NOTICE OF PROPOSED CHANGE IN PROPERTY

Petition: x437

B REQUEST TO VACATE A PORTION OF ALEXANDRINE AVE., 17 FT. WD. AND A PORTION OF SECOND AVE., 10 FT. WD. IN THE BLOCK BOUND BY SECOND, WILLIS, CASS AND ALEXANDRINE AVE.					CITY OF DETROIT CITY ENGINEERING DEPARTMENT SURVEY BUREAU JOB NO. 01-01 DRWG. NO. X 437					
A RECEIVED ADDING A CURB ON THE DISCREPANCY FROM THE CITY RECORDS					WLW	KSM	KSM	2/5/16		
DESCRIPTION					DRWN	CHKD	APPD	DATE		
REVISIONS										
DRAWN BY WLW					CHECKED					
DATE 11-20-14					APPROVED

PETITION NO. 437
 MIDTOWN DETROIT
 3939 WOODWARD AVE.
 DETROIT, MICHIGAN 48201
 C/O SUSAN T. MOSEY
 PHONE NO. 313 420-6000

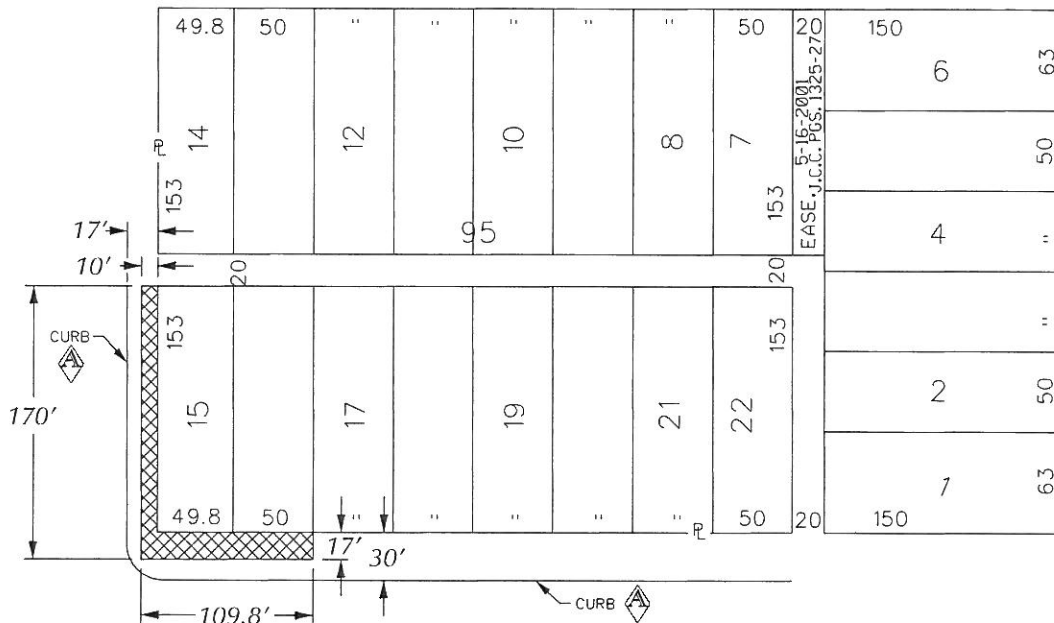
PLA has scheduled New light construction at the subject intersection. The underground utilities conflict may require to move light foundation back of sidewalk.
